PENN BUILDERS, INC.
General Contractors

RE: North Penn High School BP-2
Change Order Request #23 ASI 01 – Additional Shaft wall

Architect's Supplemental Instructions

PROJECT: *(name and address)* North Penn High School Renovations Bid Package 2	**CONTRACT INFORMATION:** Contract For: Mechanical Construction Date: 08-14-2026	**ASI INFORMATION:** ASI Number: 01 Date: 01-20-2026
OWNER: *(name and address)* North Penn School District 401 E. Hancock Street Landsdale, PA 19446	**ARCHITECT:** *(name and address)* Hord Coplan Macht, Inc. d/b/a SCHRADERGROUP Studio 555 E. North Lane, Suite 5100 Conshohocken , PA 19428	**CONTRACTOR:** *(name and address)* JBM Mechanical, Inc 3273 Gun Club Road Nazareth, PA 18064

Drawing Number:
BP2- C008

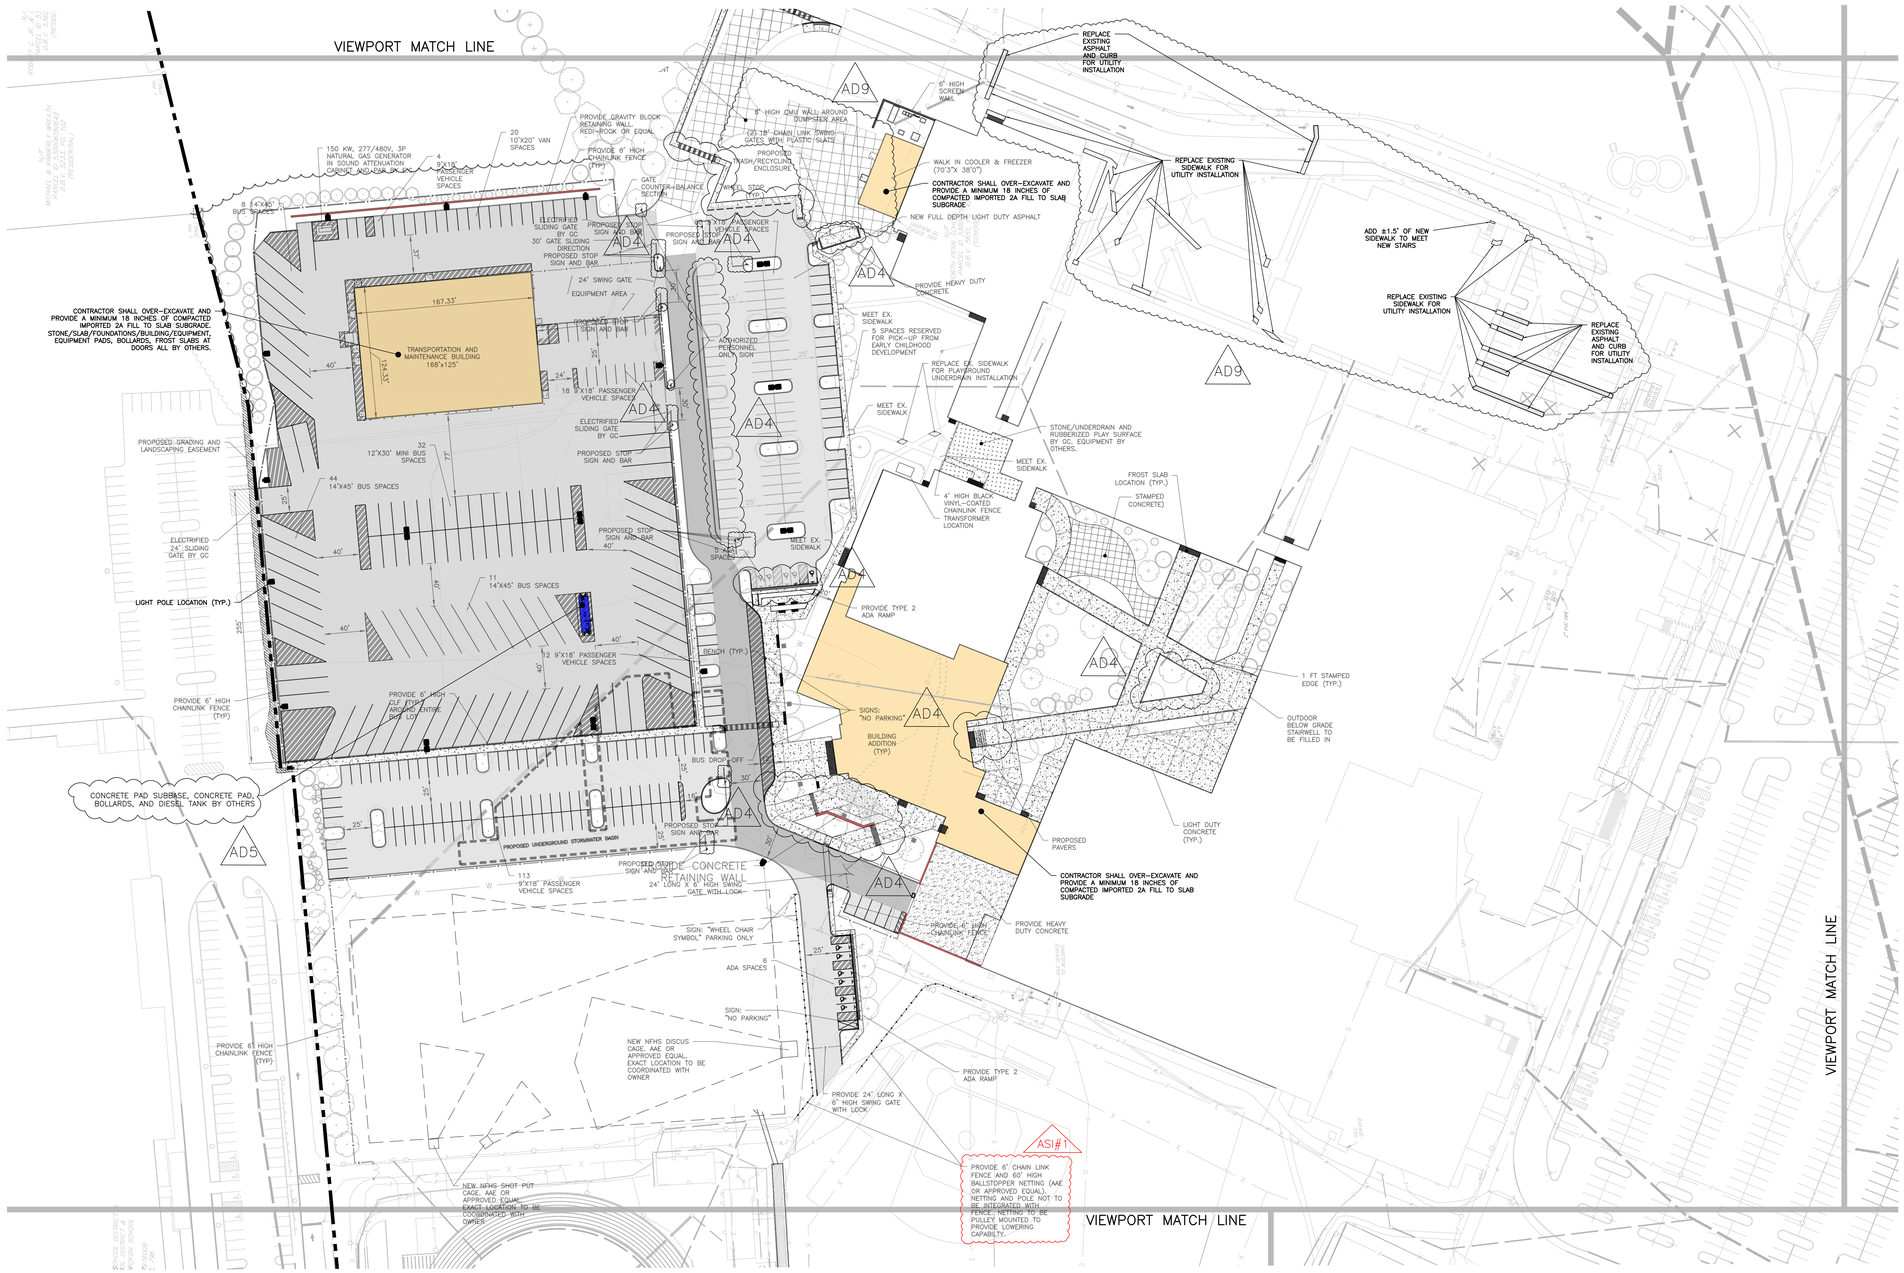
Revisions to Civil Set:
- Drawing BP2-C008; REPLACE sheet in its entirety (attached). Revise the ball stopper netting height and associated fencing connection.

Drawing Number:
BP2-A122.A1

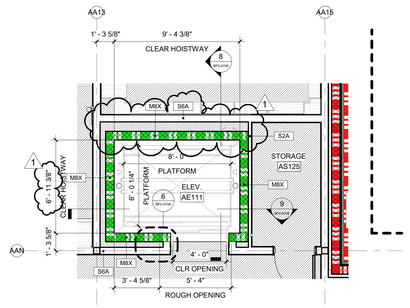
Revisions to Architectural Set:
- Drawing BP2-A122.A1; REPLACE sheet in its entirety (attached). Height of pendant lighting from Second Floor elevation to bottom of fixture provided.
- Drawing BP2-A121.E; CLARIFICATION that 6A WOOD CELING SYSTEM direction in LIBRARY E155 to run short distance to align with lighting.
- Drawing BP2-A708; REPLACE sheet in its entirety (attached). Revise ELEV1 hoistway plan dimensions, layout, and associated head and jamb details

4 ELEVATOR DOOR HEAD DETAIL

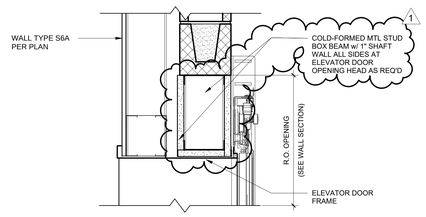
Please see below the costs associated with the changes listed in ASI 01, issued 01-26-2026. This proposal includes providing and installing an added Layer of 1" Shaft Liner to Elevator Doors per Details 4 and 6/BP2-A708.

- **Added Layer of 1" Shaft Liner to Elevator Doors per Details 4 and 6/BP2-A708 of ASI-001.**

Drawing Number:
BP2-A708

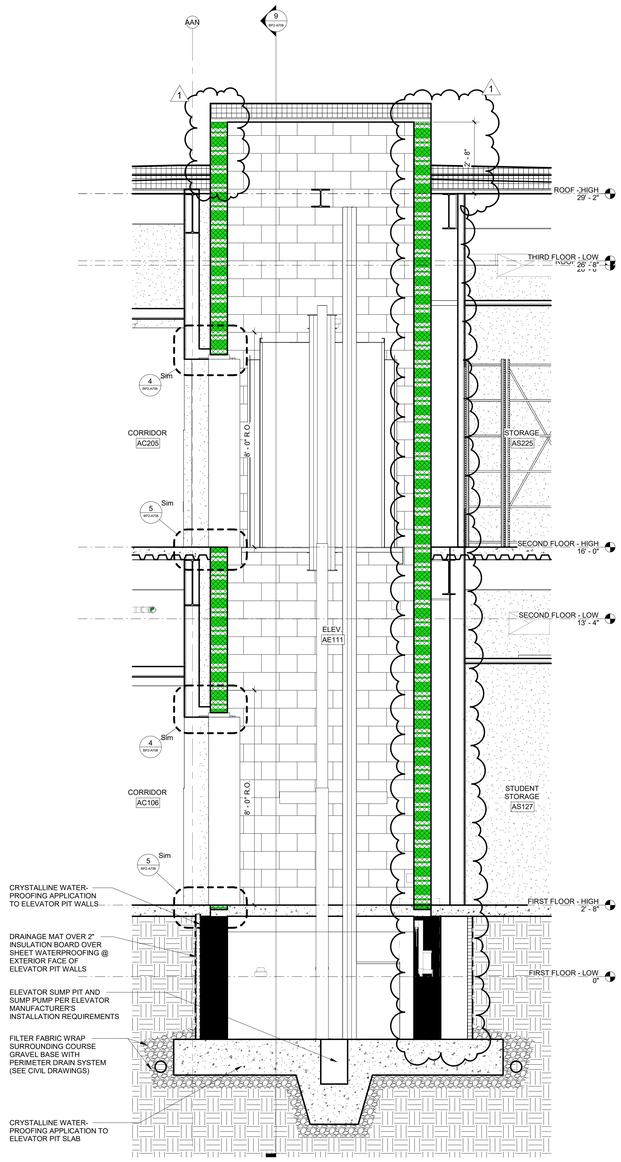
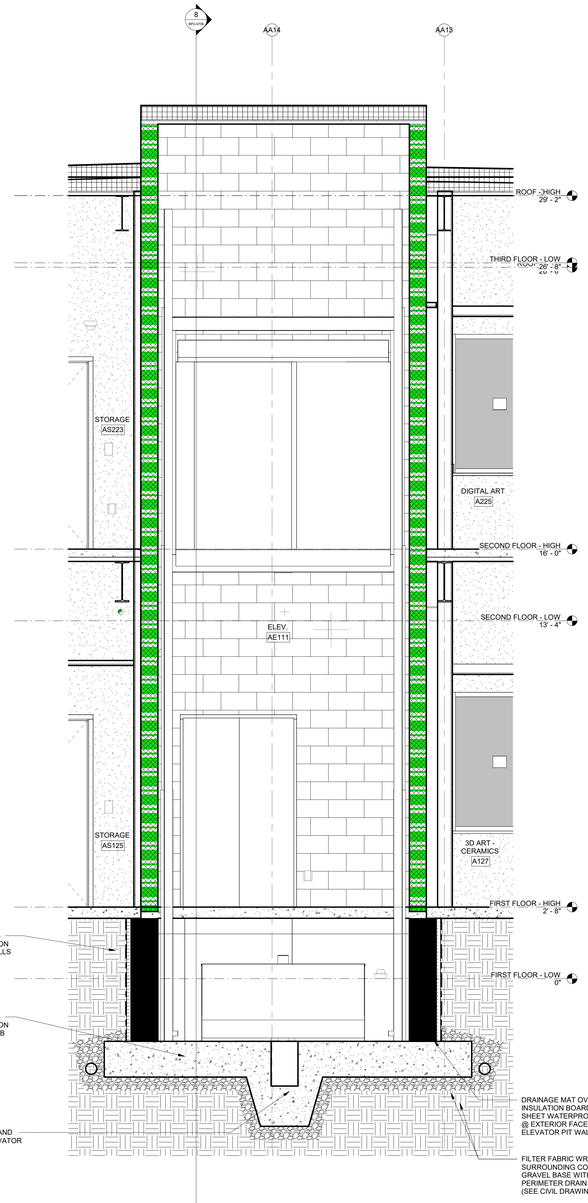
Revisions to Structrual Set:
- Modifications to structural steel framing adjacent to elevator shaft shall be made per revised sheet BP2-A708 and reflected on Revise & Resubmit For Record submittals.
